DESIGN REVIEW & PRESERVATION BOARD

LOCATION: 622 20th Street

PROPOSAL: Convert existing office/warehouse to office use. Off-street parking across alley on vacant site.

EXHIBIT A-1

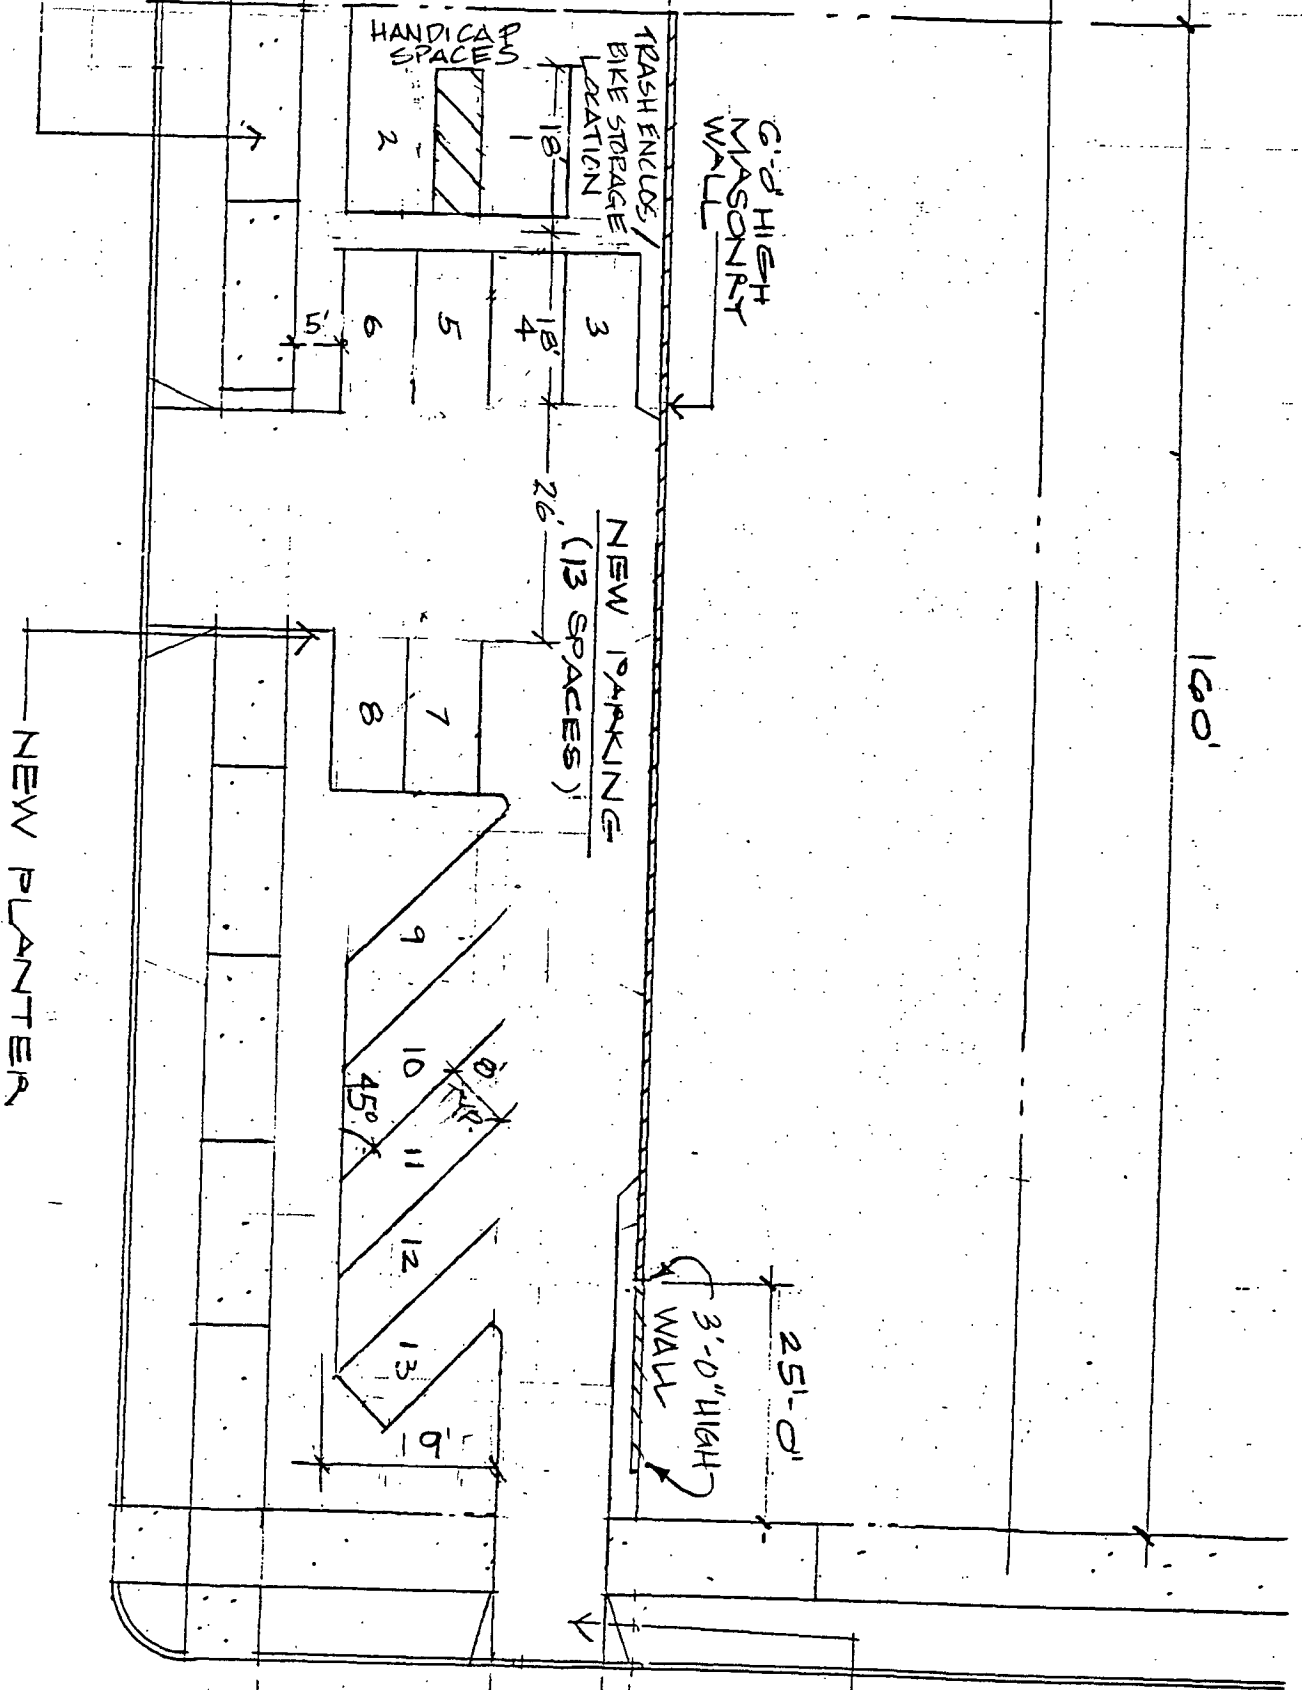
7. Staff notes a number of problems with the parking lot design and suggests a redesign based on the following:
 - a. No provision is made for handicap parking.

- b. The planter abutting the group of 3 stalls located along the alley has only a 4-foot planter, though a 5-foot width is required by ordinance.
 - c. The proposed landscaping may only marginally satisfy the 50-percent shading requirement for the parking lot.

- d. Staff suggests a redesign of the parking lot in the fashion shown on Exhibit A-1. Such design would provide:

1. Provide for 2 handicap spaces.
 2. Alleviate the aforementioned inadequate planter width.
 3. Provide greater shading potential.
 4. Accommodate a trash enclosure.

5. Possibly accommodate bike storage.
8. Signage is proposed for locations shown on the site plan. Indicated signage on the west elevation plan is actually intended for the south elevation. The colors are proposed as black and green on white. No sign layout was included on the application.

SITE PLAN

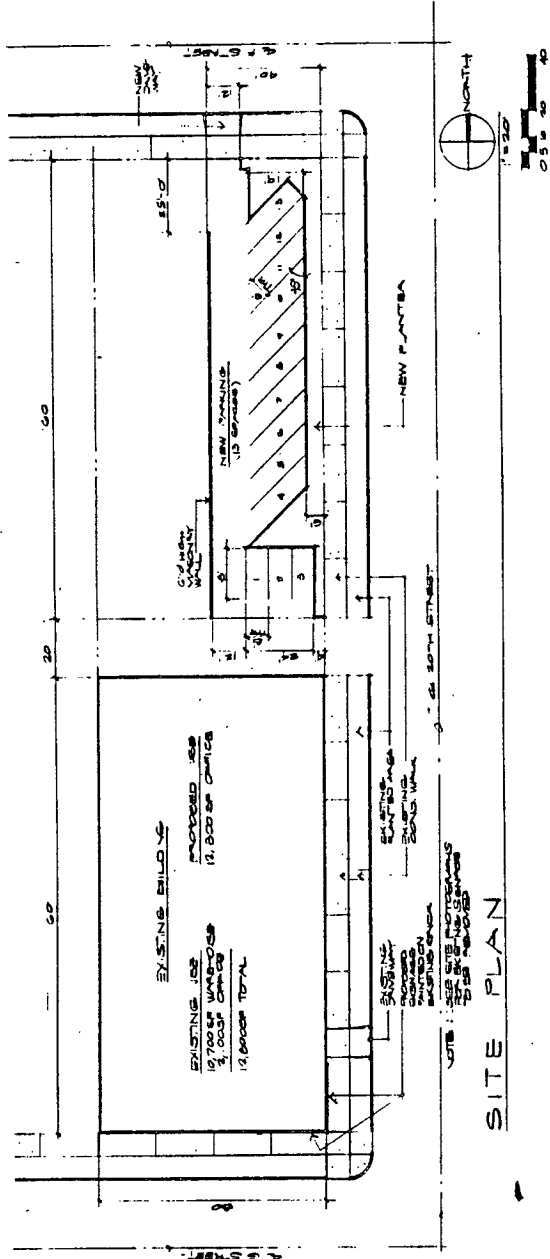
9. Plans show the retention of one of two existing overhead doors and a portion of an existing driveway to serve it. Traffic Engineering indicates however that it will not issue a permit for this driveway which would facilitate back-in unloading of trucks on the public street.

- If the number of deliveries warrant it, the City may approve a request for a curbside loading zone in lieu of alley loading/unloading.
10. The Zoning Ordinance requires a 6-foot masonry wall between the parking lot and the existing residence on "F" Street. The submitted plan shows the wall within 25-feet of the "F" Street right-of-way. Staff suggests the wall extension at 6-feet within 20 feet of the right-of-way and at 3 feet of height within 5-feet of the right-of-way.

4. The indicated 6-foot wall will be extended at a 3-foot height within 5-feet of the "F" Street sidewalk.
5. Signage design is subject to review and approval of staff.
6. An "exit only" sign shall be placed by the "F" Street driveway, location to the satisfaction of staff.
7. The applicant shall submit the following for review and approval of staff prior to issuance of building permits:
 - a. Revised site plan indicating modified parking layout, expanded planter, trash enclosure (if applicable), bike storage (if applicable), and the extended masonry wall, and the "exit only" sign location.
 - b. Detailed landscape and irrigation plans and shading plan.
 - c. Revised floor plan, if trash storage and/or bike storage is to be inside.
8. Sign design (in scale and colored) to be reviewed and approved by staff before sign permit is issued.
